Globe Electric Company Inc.

Ref: FCC Class II Permissive change for FCC ID: 2AQUQGE50333

Component changes diagram

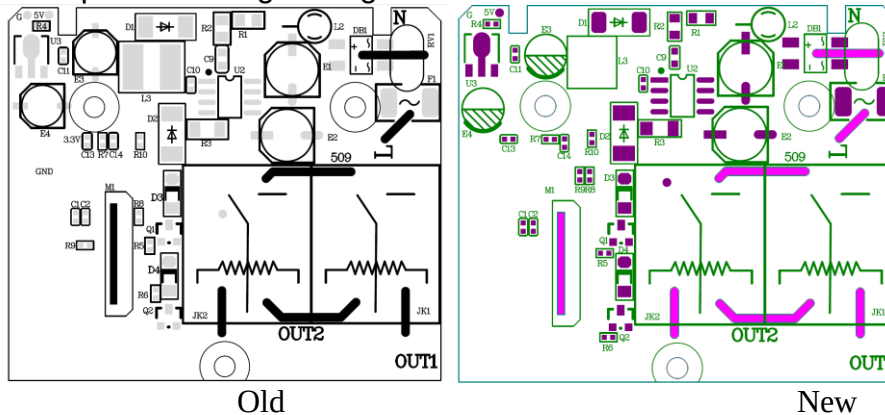
1. The package of inductance L3 from SMD/CD54 change to DIP/0810
2. The package of electrolytic capacitor E3、E4 from SMD/5*5.4 change to DIP/5*11
3. Position moved of the chip capacitor C13 and chip resistor R6、R8、R9
4. Direction changed of the chip resistor R5、R7

Circuit modification diagram
TOP layer circuit

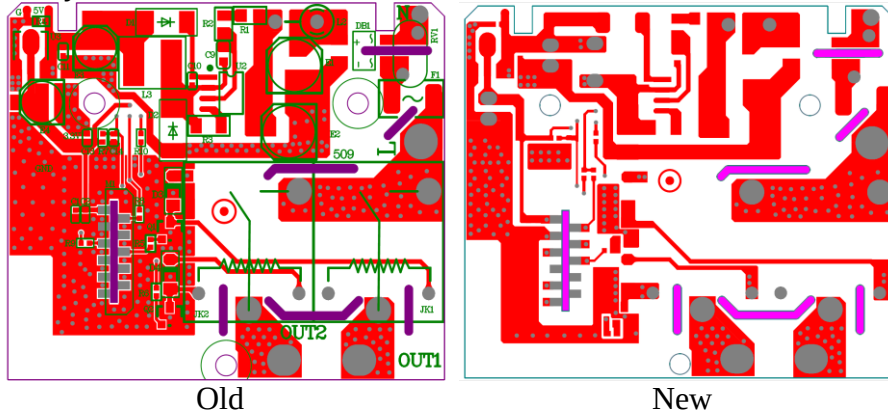
Note: Changes to the circuit on the left side of the black marking

BOTTOM circuit

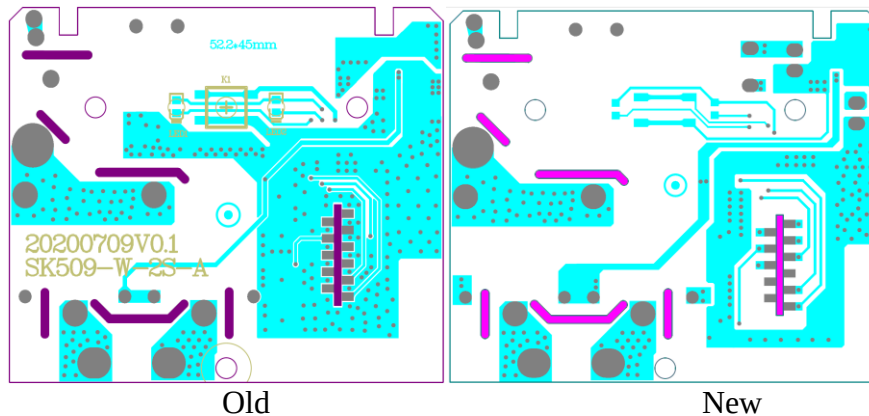
Note: The circuit modification on the right side of the black marking line
